ADDENDUM 1

BID TITLE: File No. 99-24 2024 Halloran Skate Park Roof and Envelope Improvements

ADDENDUM #1

2024 Halloran Skating Rink Roof & Envelope Improvements

Cotterman Co. Access Ladder

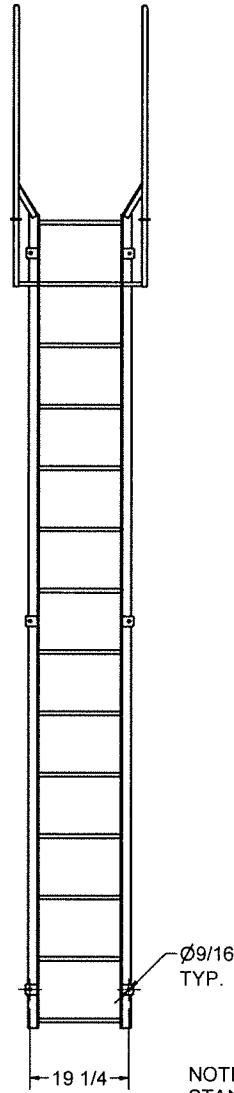
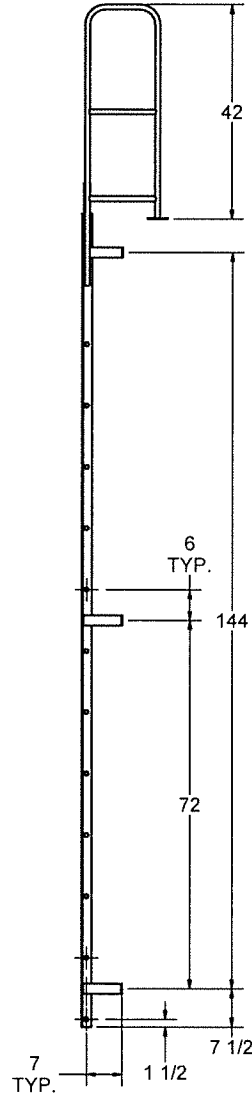
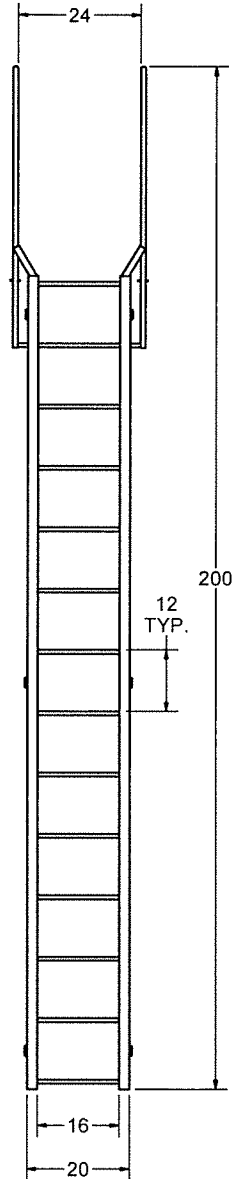
Is there a spec for the wall ladder?

See attached or equal in the appendix.

This product was the inspiration of design for the Access Ladder (2 Pages)
